HSSD2 High Speed fabric door — 9500mm x 6000mm.

CLIENT: INGERSOL RAND INDIA PRVT LTD

PROJECT: INGERSOL RAND FACTORY EXPANSION @ HMADABAD, INDIA

TITLE: MEGA DOOR S1000

INTERNAL ELEVATION (WHEN DOOR IS CLOSED)

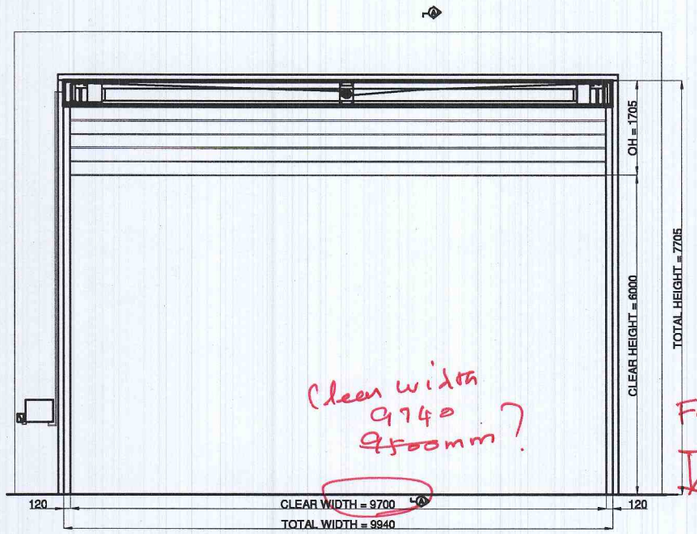
Note #3 Fixing Detail of the motor with PEB structure.

Note #2 Show fixing detail for the control panel with the wall cladding member.

Note #1 — The framed opening size of the fabric door should be coordinated with PEB Vendor.

SECTION A-A

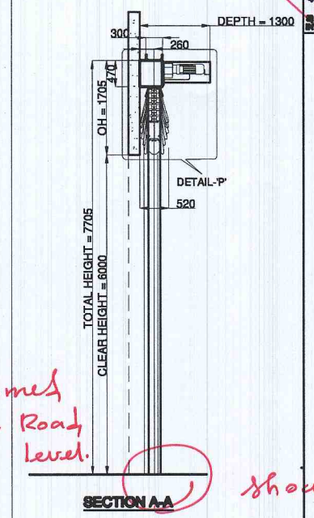
Show detail at the floor level.

DETAIL-'Q'

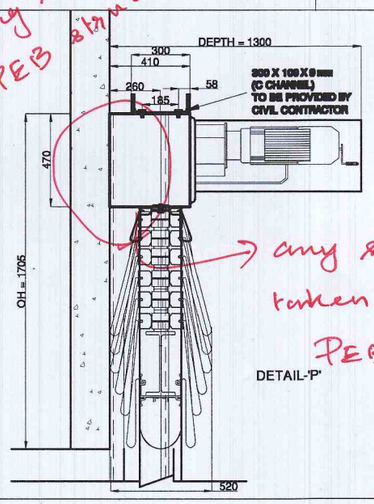
Note #4 Show Flashing arrangement between the supporting structure and the PEB structure.

→ any support fr taken from the PEB structure?
